Access Compliance Report

Public Rights-of-Way

(Curb Ramps)

Intersection ID: 47231	Main Street: ROMANY_RD	Cross Street: MOREHEAD_MEDICAL_DR	Location: SE
ADA ID: 2EAF1216E1D8	Ramp Type: PerpDiag	Initial Pass/Fail: Fail	Overall Compliance: No
Codes/Mitigation Info/Possible Solution		Field Measurements/Component Compliance	
		Severity Score: 50

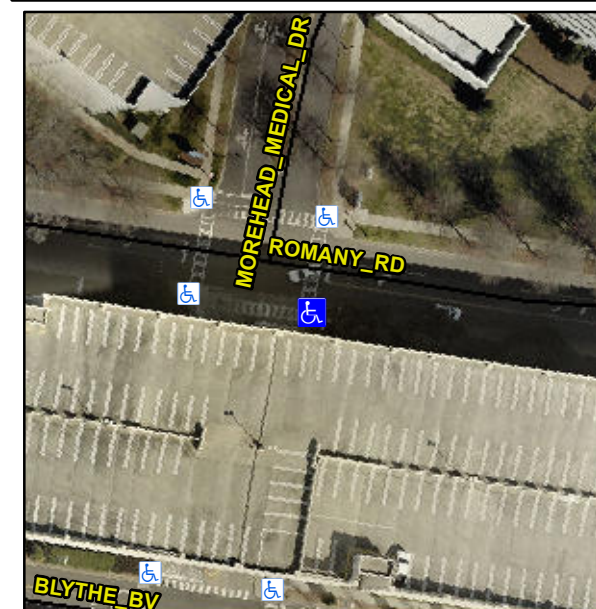
R304.2.2, R304.5.3

Compliance	Description	Data	Compliance	Description	Data
N/A	Ramp Length (in)	47.0	No	Ramp Slope (%)	17.5
Yes	Ramp Width (in)	93.0	No	Ramp XSlope (%)	8.9
N/A	Flare Type LT	N/A	N/A	Flare Type RT	N/A
N/A	Flare Slope LT (%)	N/A	N/A	Flare Slope RT (%)	N/A
N/A	Flare Traversable LT?	N/A	N/A	Flare Traversable RT?	N/A
N/A	Landing Length (in)	N/A	N/A	DWS Provided?	N/A
N/A	Landing Width (in)	N/A	N/A	DWS Contrast?	N/A
N/A	Landing Slope (%)	N/A	N/A	DWS Length (in)	N/A
N/A	Landing X Slope (%)	N/A	N/A	DWS Full Width?	N/A
N/A	Landing Curb? (Y/N)	N/A	N/A	DWS Offset (in)	N/A
N/A	Shared Landing?	N/A			
N/A	Gutter Ponding?	N/A	N/A	Gutter Slope (%)	N/A
N/A	Gutter Lip Ht (in)	N/A	N/A	Gutter X Slope (%)	N/A
N/A	Painted X Walk1?	Yes	N/A	Painted X Walk2?	Yes
	X Walk 1 Direction	To N		X Walk 2 Direction	To W
N/A	X Walk 1 Width (in)	57.0	N/A	X Walk 2 Width (in)	60.0
	X Walk 1 Slope (%)	0.6		X Walk 2 Slope (%)	1.8
	X Walk 1 X Slope (%)	2.0		X Walk 2 X Slope (%)	3.8

N/A	Ramp inside XWalk1?	Yes	N/A	Ramp inside XWalk2?	Yes
	Road Slope (%)	9.0	N/A	Clear Space?	N/A
	Road X Slope (%)	0.5	N/A	Clear Space to XWalk (in)	N/A
N/A	Any Obstructions?	N/A	N/A	Storm Grate/Utility Hazard?	N/A
	Obstruction Type			Storm Grate/Utility Type	
		N/A			N/A
		Yes		Surface Condition? (G/P)	Good

Remove & Replace Curb Ramp With Two New Directional Ramps or Equivalent.
